SUMMARY OF CONCERNS IN RELATION TO THE PROPOSED NORTHCONNEX TUNNEL

This is an objection to many aspects of the proposed NorthConnex tunnel.

SECTION A: THE CONNECTIVITY OF NORTHCONNEX SOUTHERN VENTILATION FACILITY AT THE SOUTHERN INTERCHANGE, THE SOUTHBOUND TUNNEL IN PARTICULAR

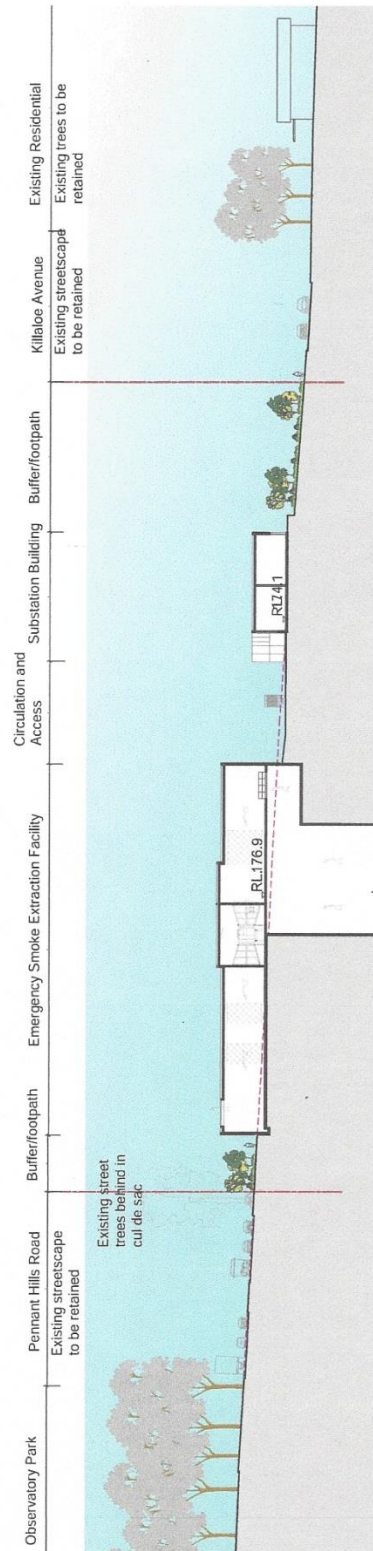
EIS page 135 *Page 11 below* there is a very explicit diagram showing the *Northern Ventilation Facility – cross section*.

EIS page 134 *Page 12 below* there is a very explicit diagram showing the *Northern Ventilation Facility – long section*.

Why are there no comparable diagrams for the Southern Interchange and the Southern Ventilation facility?

- Diagrams need to be provided showing the inter-relation between the shaft, the ventilation outlet and the motorway operations centre with a clear description of what is to be constructed and how it will operate.
- The community needs irrefutable evidence that the polluted air from the southbound tunnel exit portals will not be allowed to flow like an invisible sewer through West Pennant Hills, North Rocks, Carlingford and Beecroft.
